Rev.	Date	By	Ckd	Description
I	17/08/2023	WN	DN	S4.56 Issue 2

30 Fairlight St, Fairlight
30 Fairlight St,
Fairlight, NSW 2094

SCHEDULE OF CHANGES

Project Name	30 Fairlight St, Fairlight	Project Number	00012781
Project Address	30 Fairlight St, Fairlight, NSW 2094	Drawing Name	Sections - Sheet 3
		Scale	1:1 (A3)
		Date	August 2023
Client	Adjani Pty Ltd	Drawing Number	DA402
		Revision	G

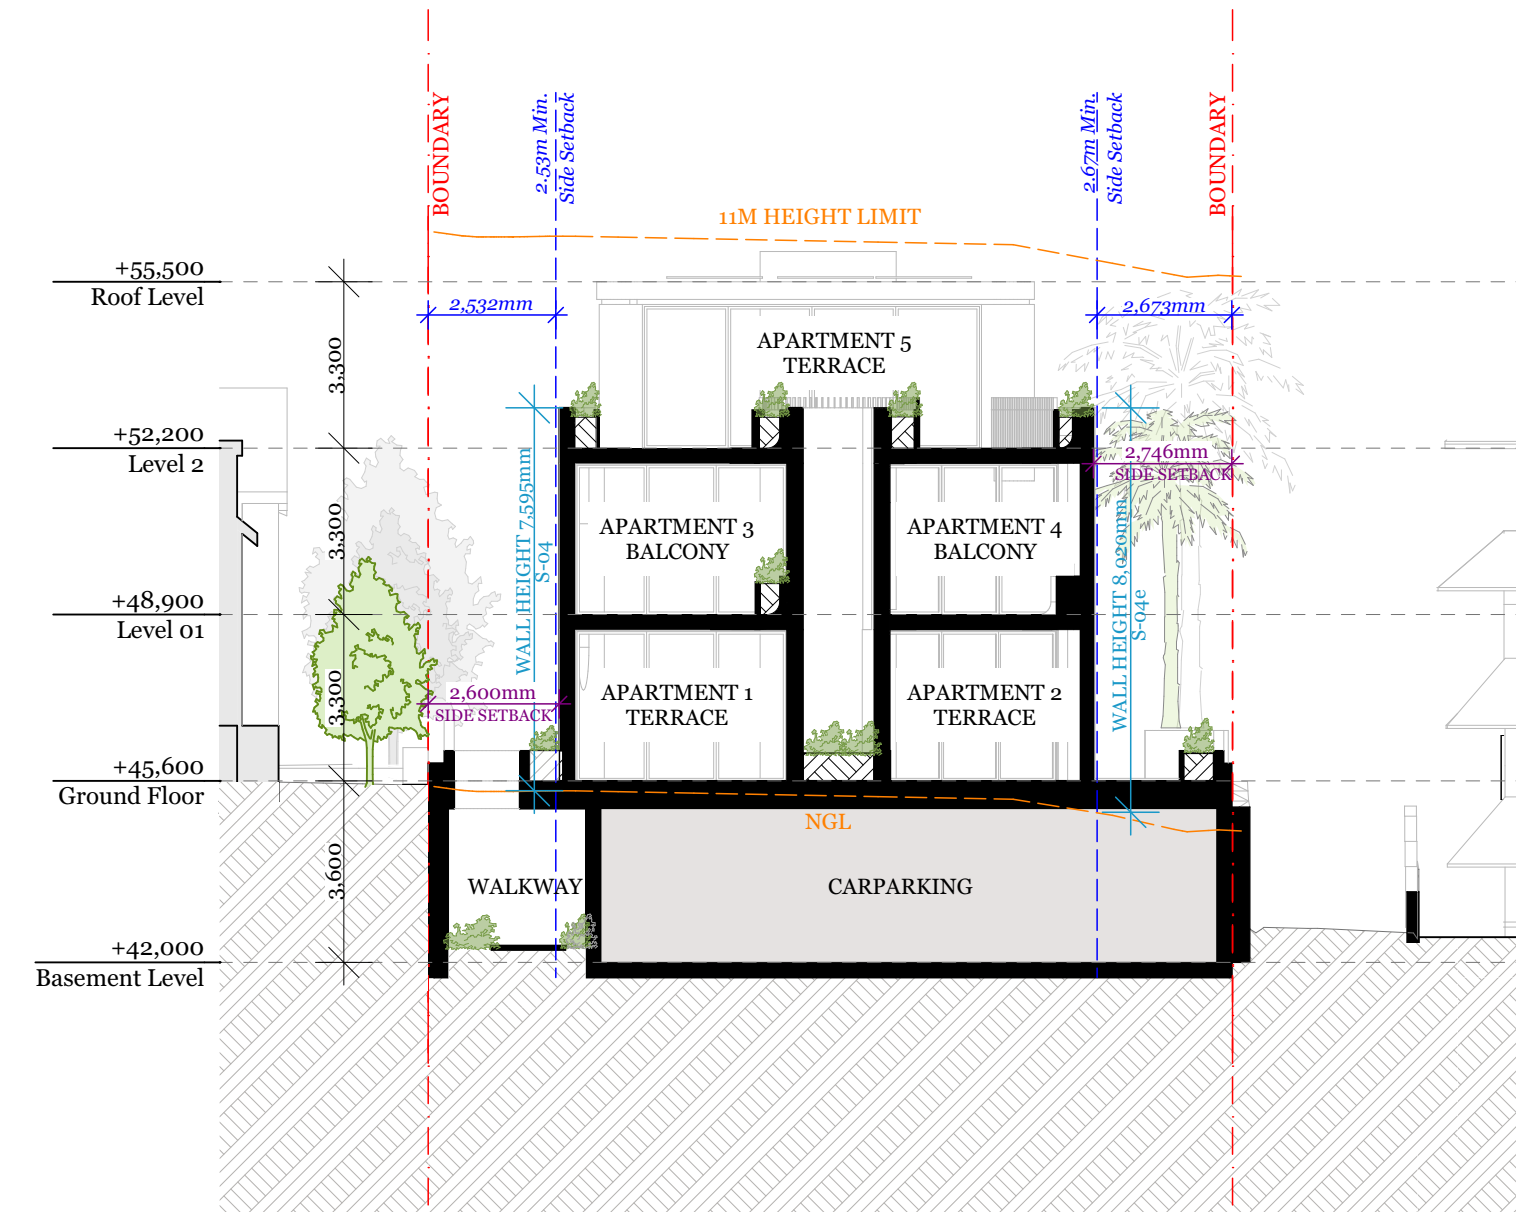
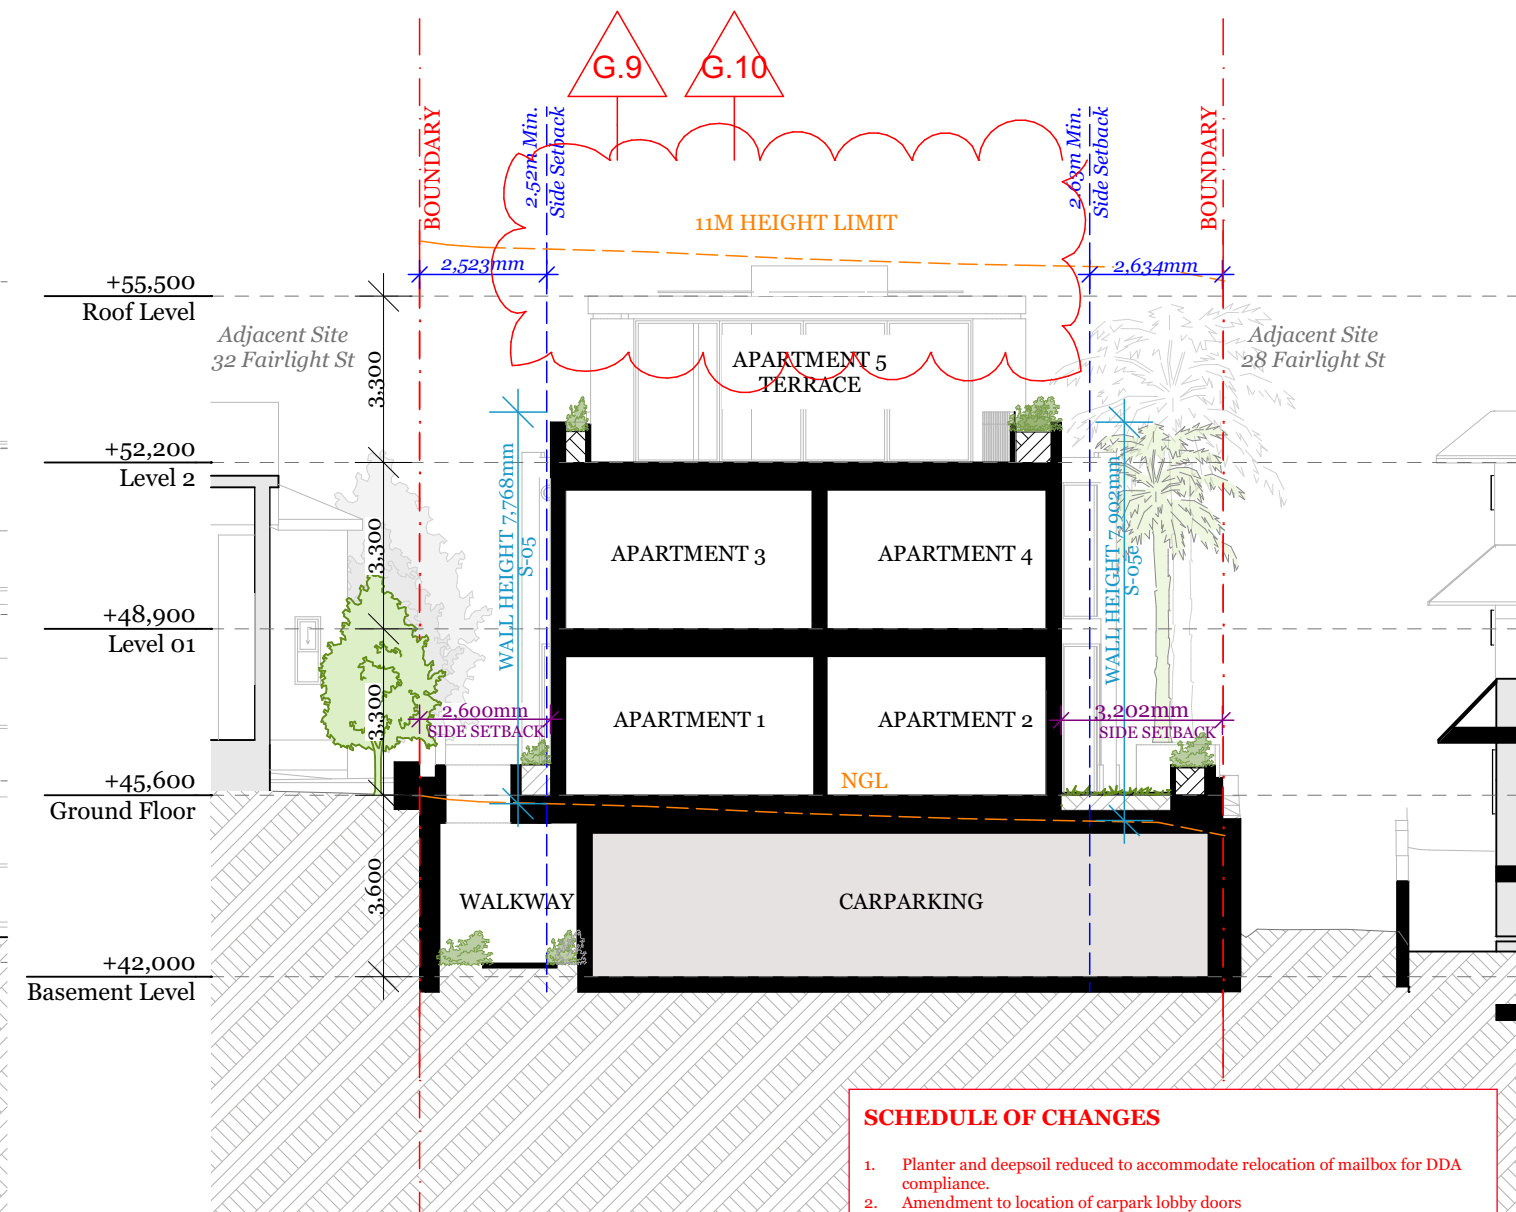
SCHEDULE OF CHANGES	
1.	Planter and deepsoil reduced to accommodate relocation of mailbox for DDA compliance.
2.	Amendment to location of carpark lobby doors
3.	OSD tank extended to accommodate minimum volume as per Stormwater Engineer's report.
4.	Additional door added for compliance as alternate fire egress with NCC D2D6.
5.	Landscaping and planter replaced with terrace hardscape to accommodate OSD tank volume below.
6.	Wall of front terrace rationalised for buildability
7.	Window opening reconfigured.
8.	Internal layout reconfigured and rationalised
9.	Plant services added onto roof including AC condensers, hot water units and mechanical vent exhausts to be concealed with metal screen enclosure
10.	PV panels added.
11.	Skylights deleted.
12.	Solid access hatch cover amended to glazed hatch.
13.	Courtyard landscape amendment.

Project Name	30 Fairlight St, Fairlight	Project Number	00012781
Project Address	30 Fairlight St, Fairlight, NSW 2094	Drawing Name	Sections - Sheet 4
		Scale	1:1 (A3)
		Date	August 2023
Client	Adjani Pty Ltd	Drawing Number	DA403
		Revision	G

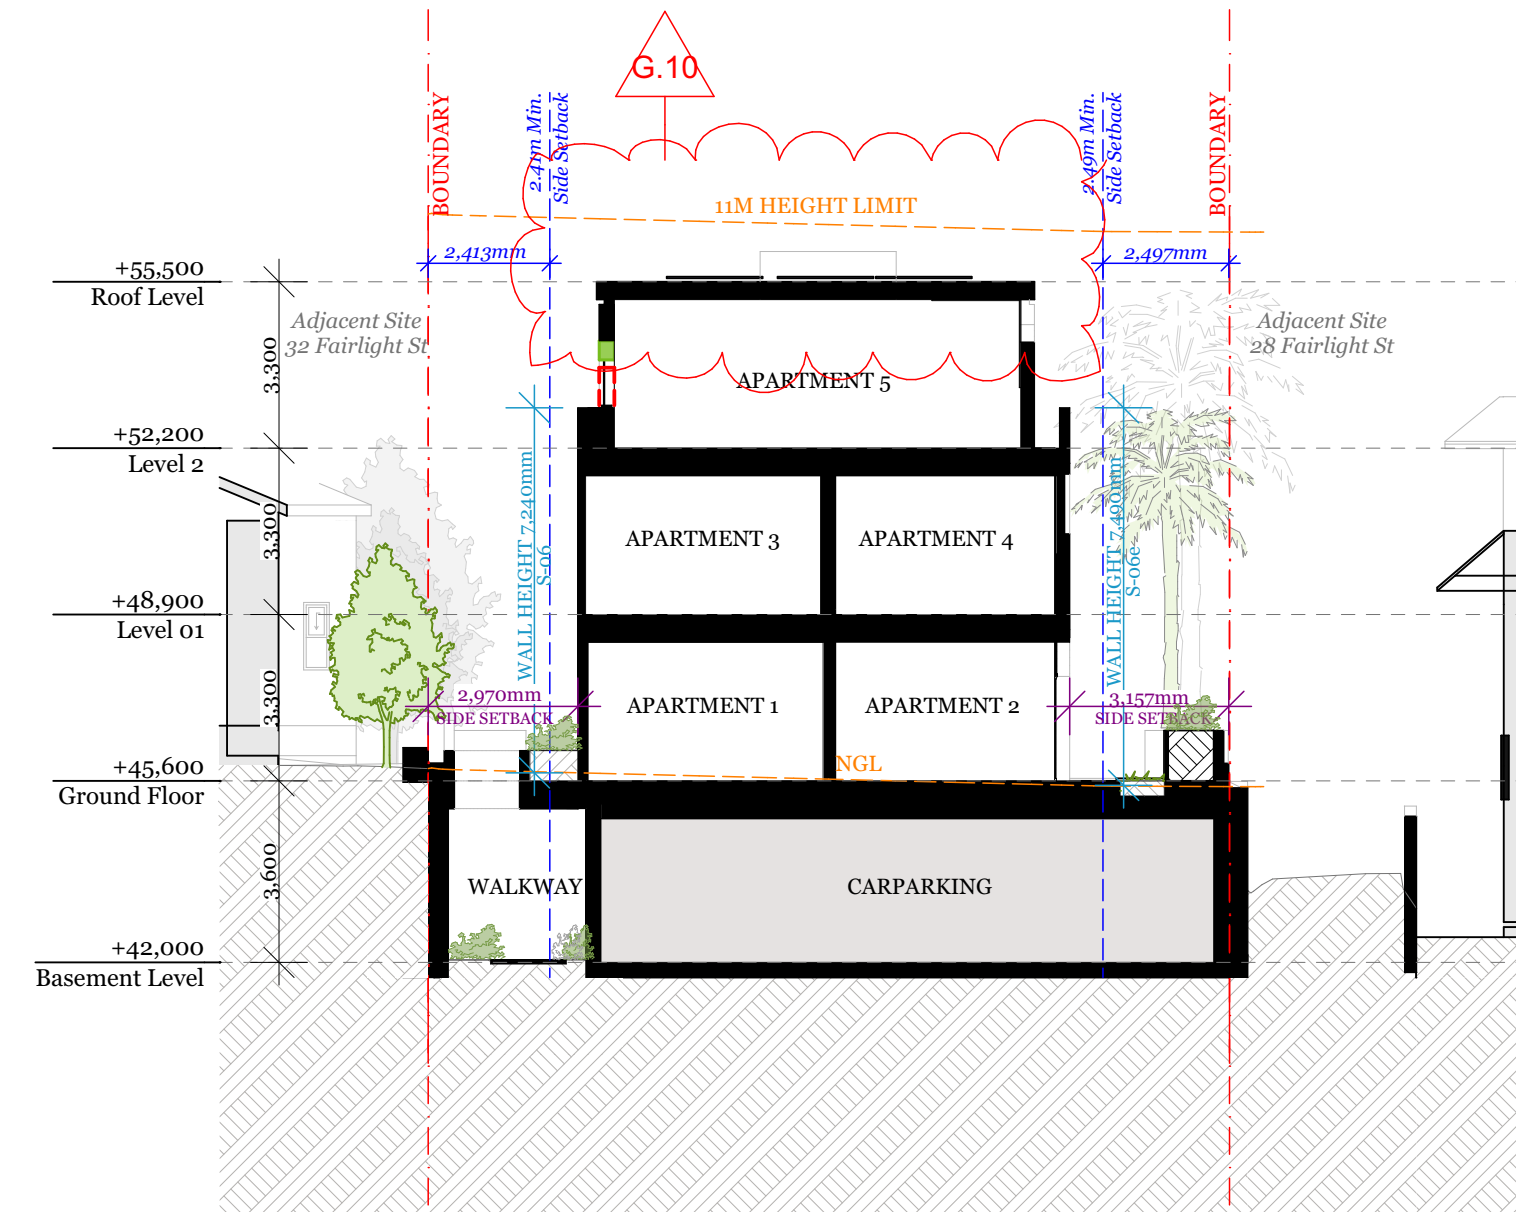
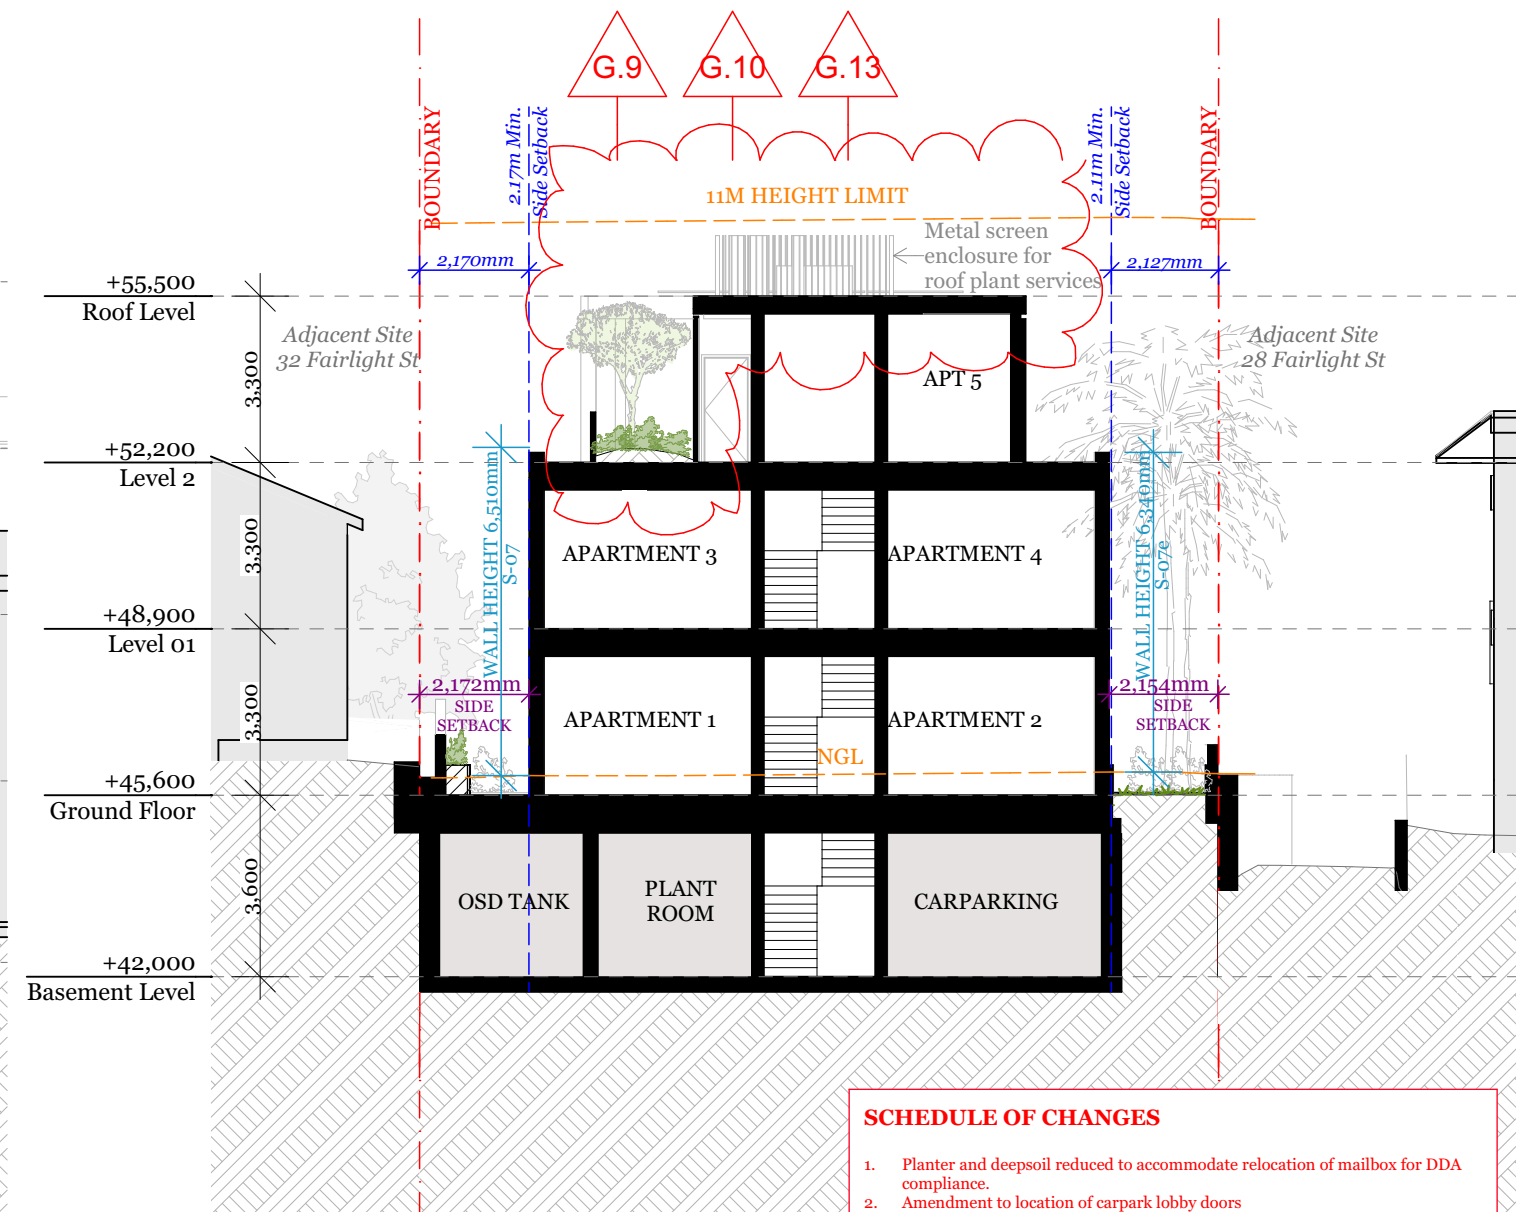
SCHEDULE OF CHANGES	
1.	Planter and deepsoil reduced to accommodate relocation of mailbox for DDA compliance.
2.	Amendment to location of carpark lobby doors
3.	OSD tank extended to accommodate minimum volume as per Stormwater Engineer's report.
4.	Additional door added for compliance as alternate fire egress with NCC D2D6.
5.	Landscaping and planter replaced with terrace hardscape to accommodate OSD tank volume below.
6.	Wall of front terrace rationalised for buildability
7.	Window opening reconfigured.
8.	Internal layout reconfigured and rationalised
9.	Plant services added onto roof including AC condensers, hot water units and mechanical vent exhausts to be concealed with metal screen enclosure
10.	PV panels added.
11.	Skylights deleted.
12.	Solid access hatch cover amended to glazed hatch.
13.	Courtyard landscape amendment.
